## FC-BB-2 meeting 10/08/01 (San Diego, CA)

**FC-BB-2 Document Update, Rajagopal (Lightsand), 01-492v0**

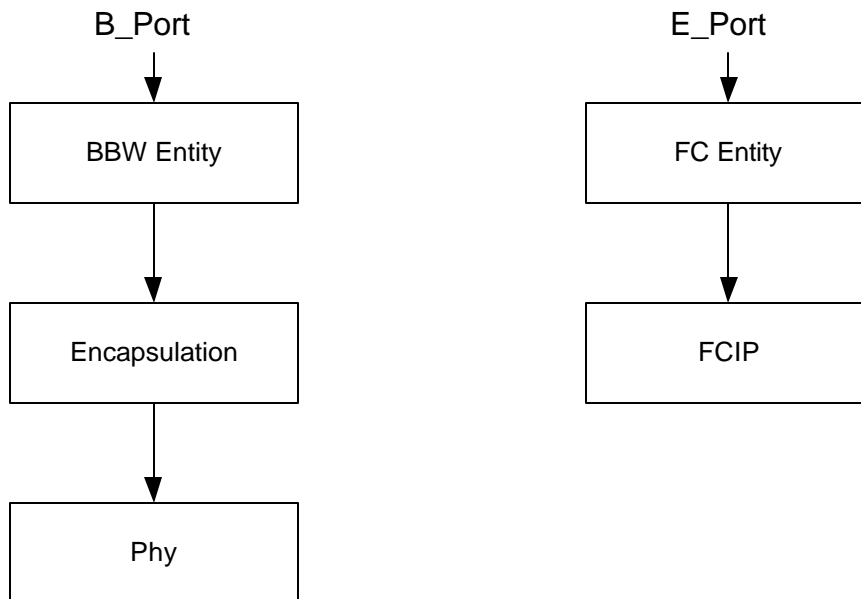
There was extensive discussion on whether there is an interface being defined in Figure 1 between the FC Entity and FCIP and if the FC Entity applies to both FC-BB and FCIP. Various parties had different interpretations of the figure. It was pointed out that Figure 1 attempts to show the relationship between previous FC-BB work and FC-BB-2 work. It was agreed to modify Figure 1 so that there is a BBW Entity and BB-2 Entity instead of a single FC Entity (see below).

- **Action Item #4: Steve Wilson to request management companies to discuss discovery techniques.**
- **Action Item #15 – All to investigate new requirements for management and forward them to Steve Wilson.**
- **Action Item #21 – Murali Rajagopal to add a note in BB2 to say that BBW SONET mapping is different from the native SONET mapping being defined in 10GFC.**
- **Action Item #22 – Murali Rajagopal to incorporate document 01-342v1 into the next draft of BB-2.**
- **Action Item #24 – Murali Rajagopal to incorporate agreed changes to figure 1 in FC-BB-2.**
